## **Burlington Design Advisory Board**

### **DESIGN ADVISORY BOARD Tuesday, February 14, 2023 3:00 PM**

## MEMORANDUM

**To:** Design Advisory Board  
**From:** Scott Gustin & Garret King  
**Re:** 98 Sunset Cliff Road  
**Date:** February 14, 2023

EXTERIOR  
ELEVATIONS

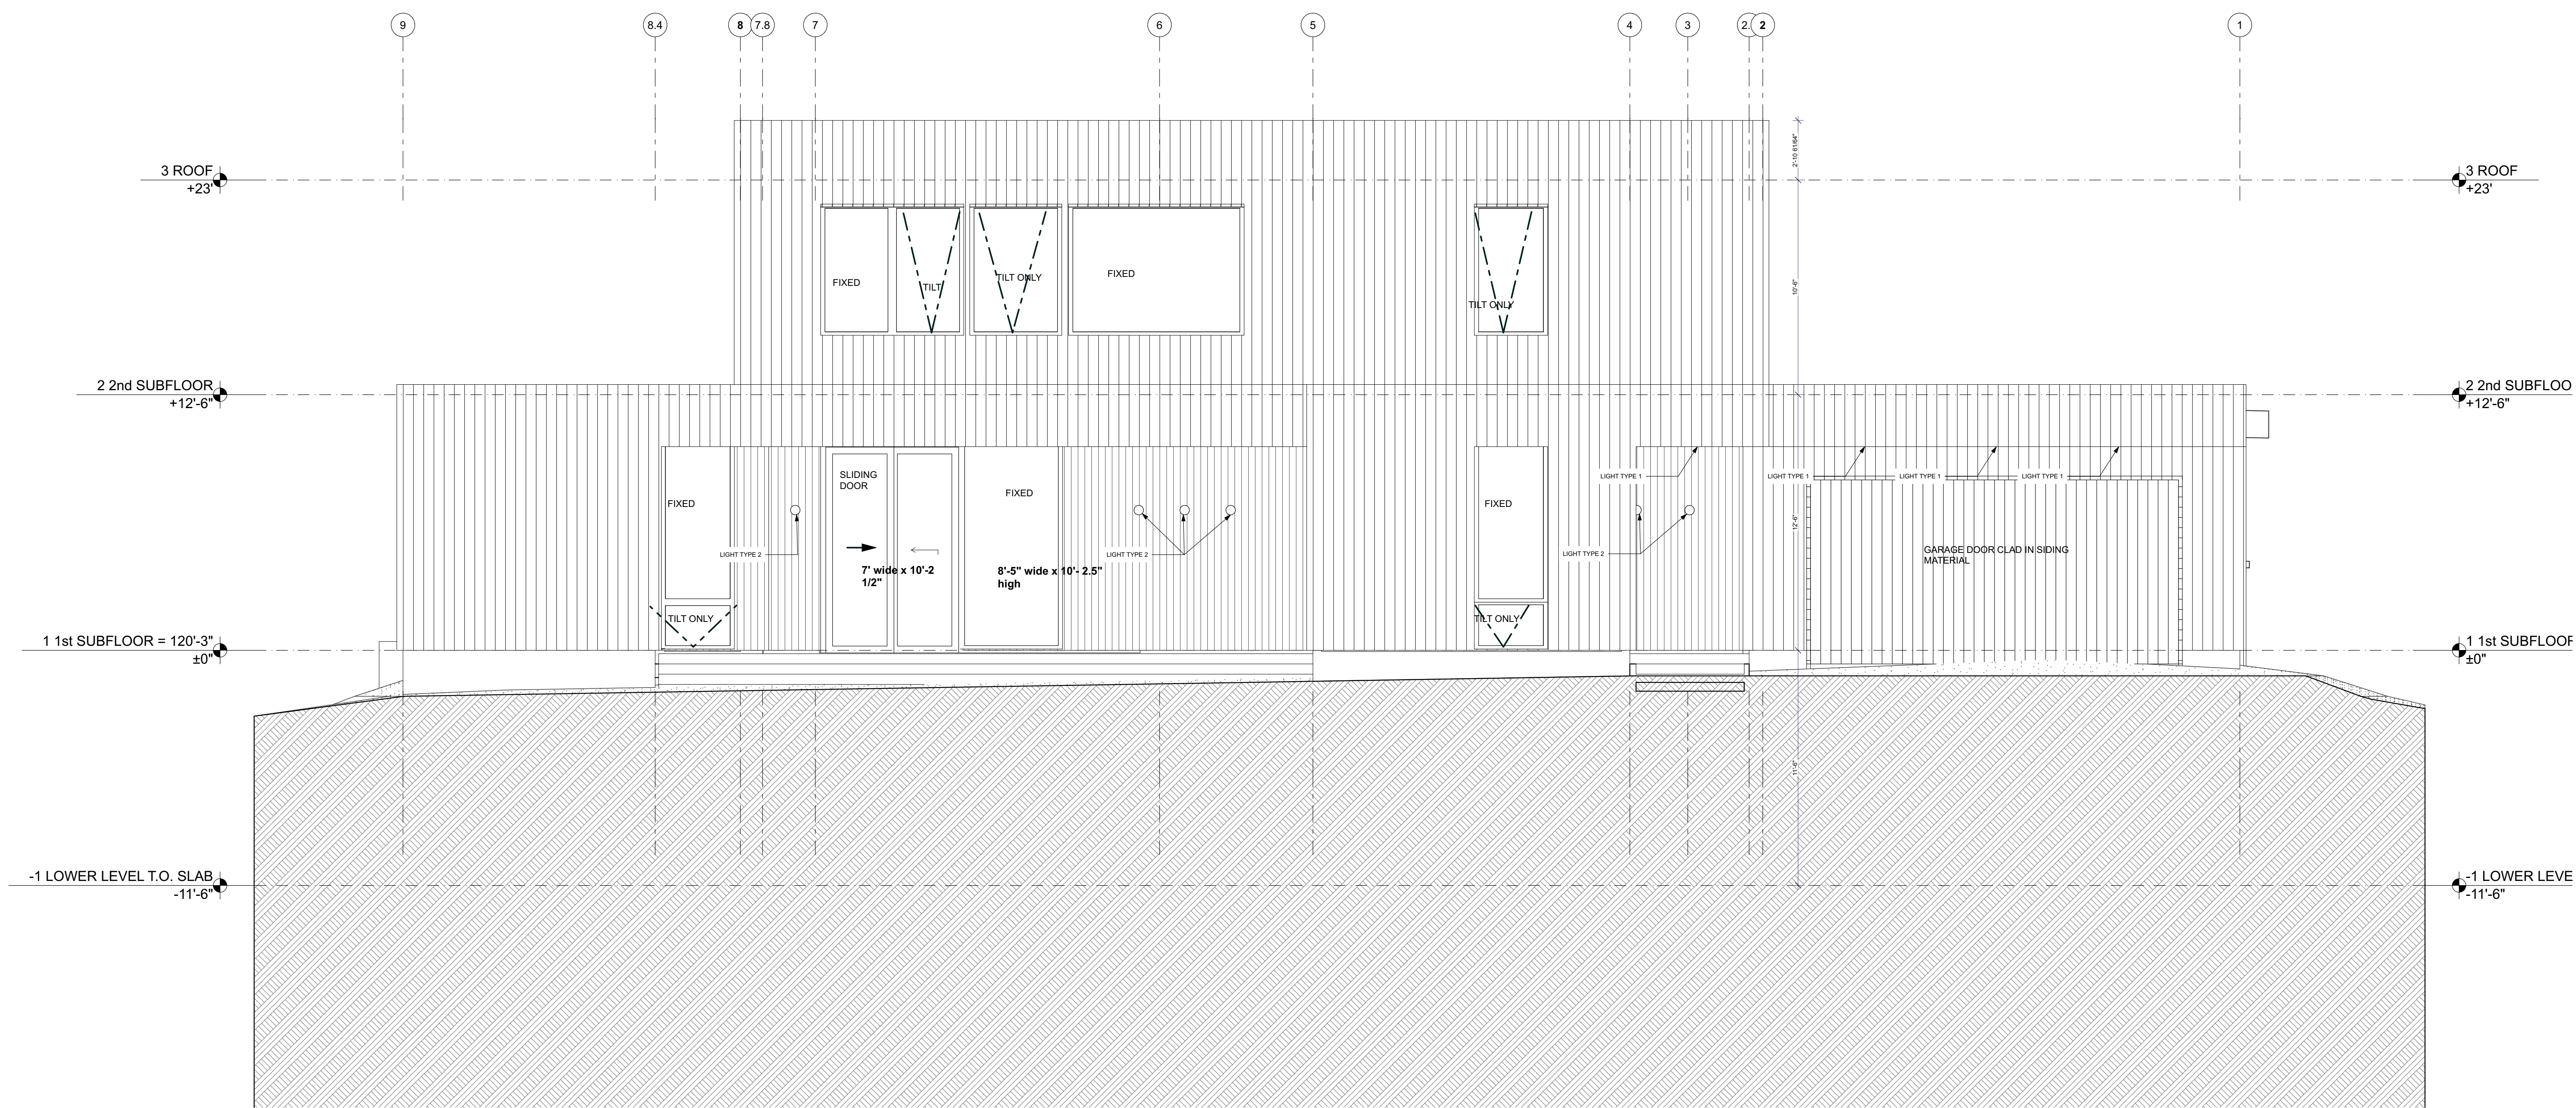
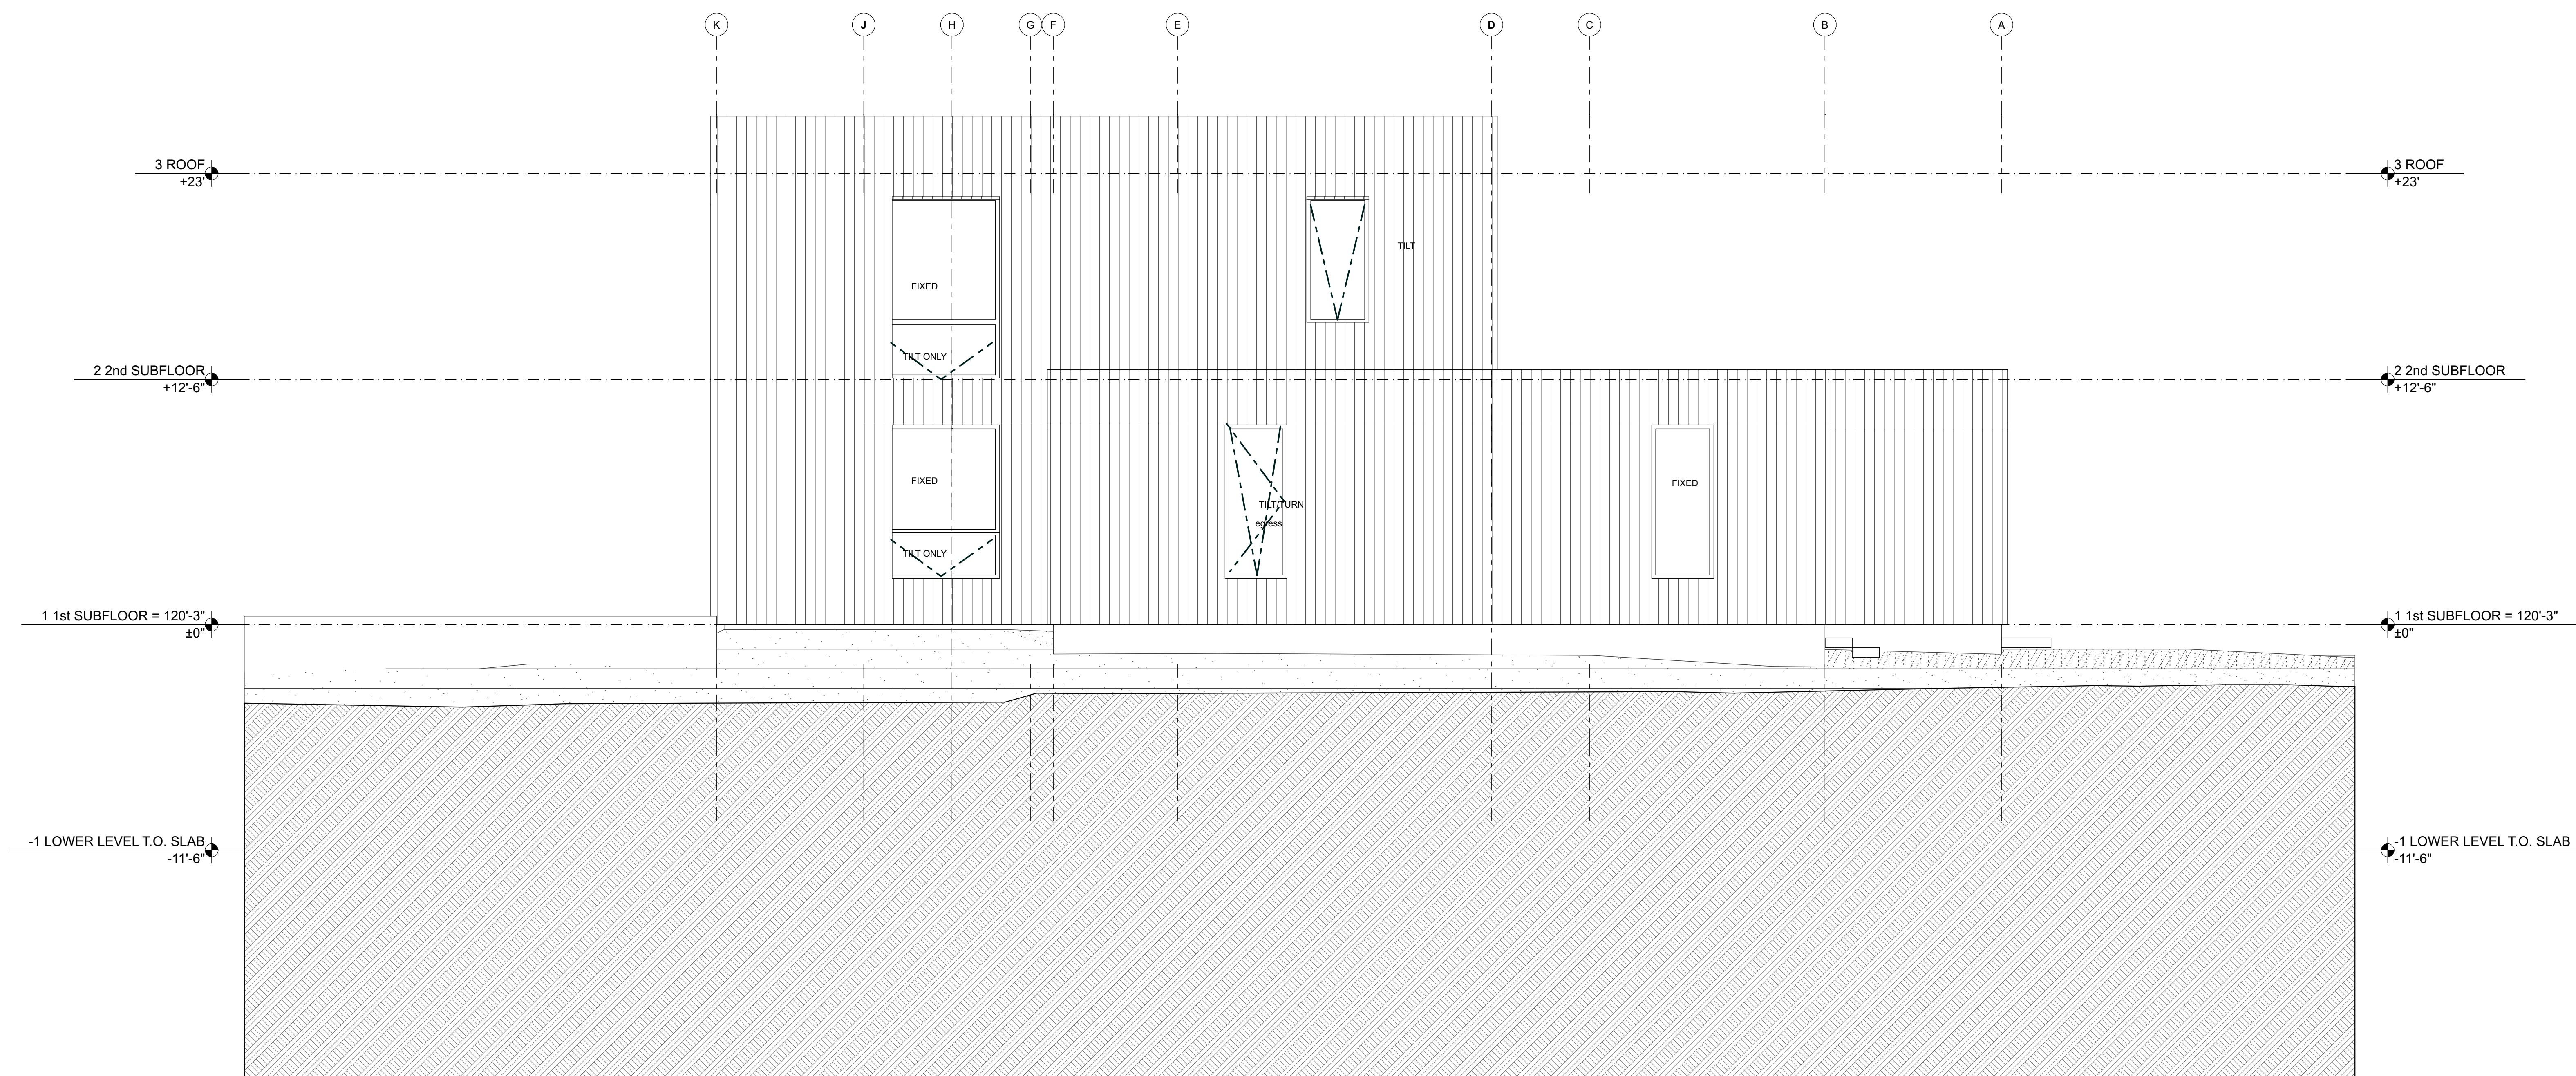
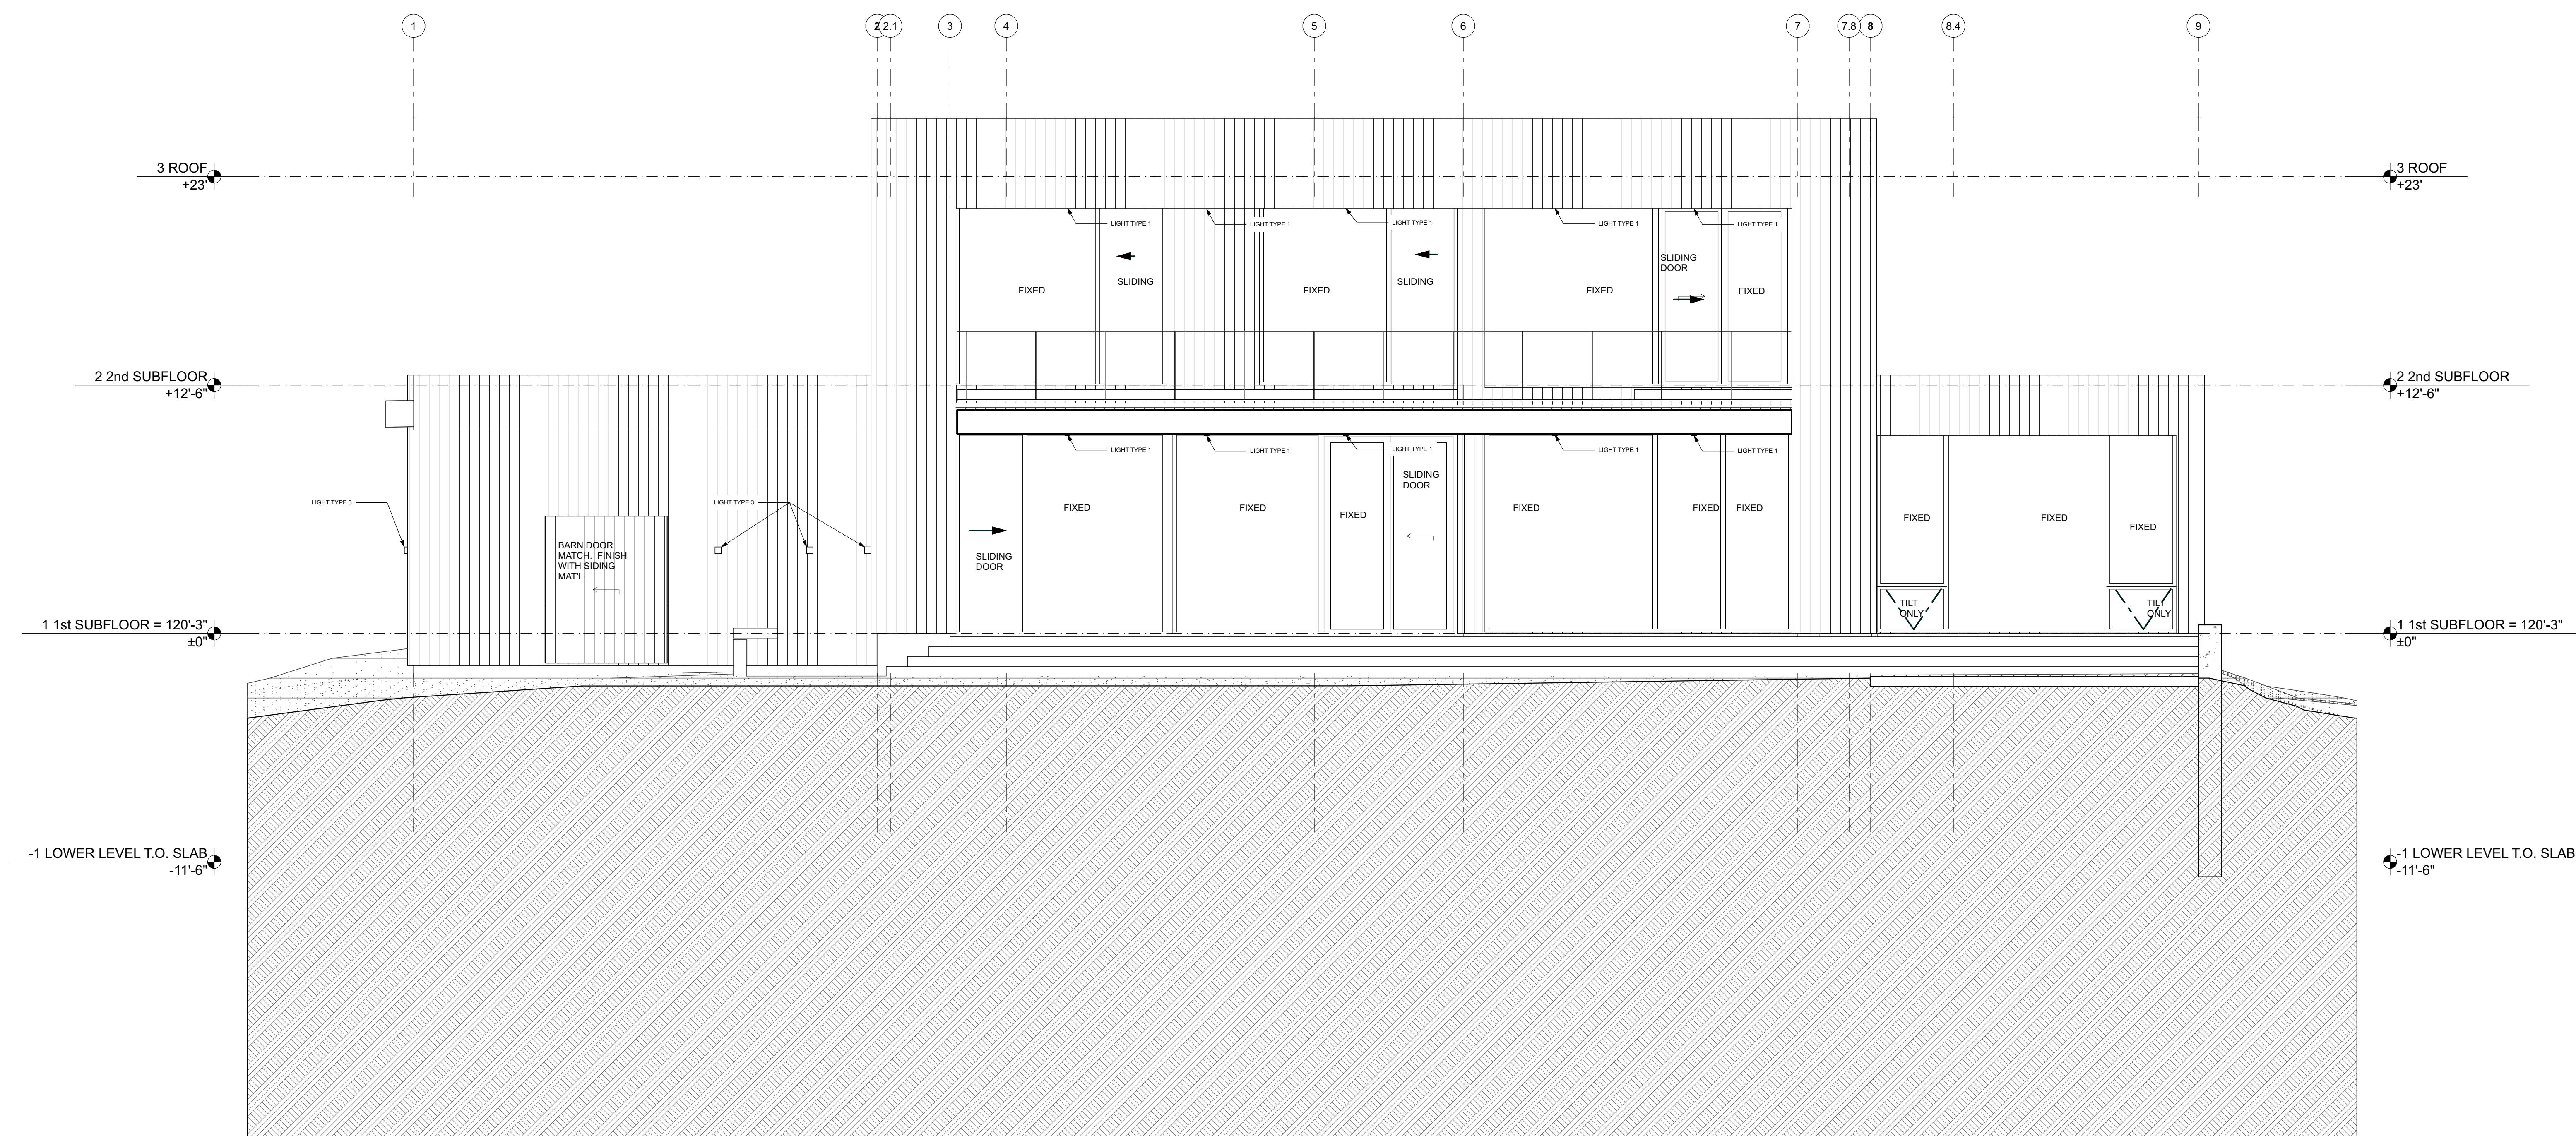
Outdoor lighting fixture specifications have been provided. Lighting locations are shown in the elevations drawings. Fixtures include: Type 1 (Recessed 700 lumen output), Type 2 (Decorative sconce 100 lumen output), Type 3 (Discreet wall sconce 701 lumen output). All proposed outdoor lighting fixtures utilize low output lamps and are acceptable for this residential installation.

The proposed home, along with its accessory porches, is similar in size and mass to the current home. The mass of the house will be defined by straight lines and square edges that clearly define the individual components of the house. It appears to have a symmetrical appearance when viewed from the front with two floors in the center and lower single stories extending off to the right and left sides. The proposed structure will be two stories just like the current building. The scale of the home is similar to nearby properties on the street including the additional attached porches. The reduced setback from the road is less than adjacent properties which pulls the new build away from the lakeshore. A perspective drawing should be provided.

The roof will be a dark colored flat membrane roof squared off with parapets matching the building siding that conceal the roof deck. This style is different from the more common hip and gable type roofs on the adjacent properties. The proposed roof design; however, is consistent and matches the modern style of the building.

The color and material for the new construction will mainly consist of dark charred wooden siding. The parapet extending above the flat roof deck will be clad in the same material. Accent siding for the covered entry and porch will be a stained wooden material. The aluminum clad wooden windows will be a black/dark color to match the siding of the house. The materials proposed are of acceptable quality and durability for this new construction.
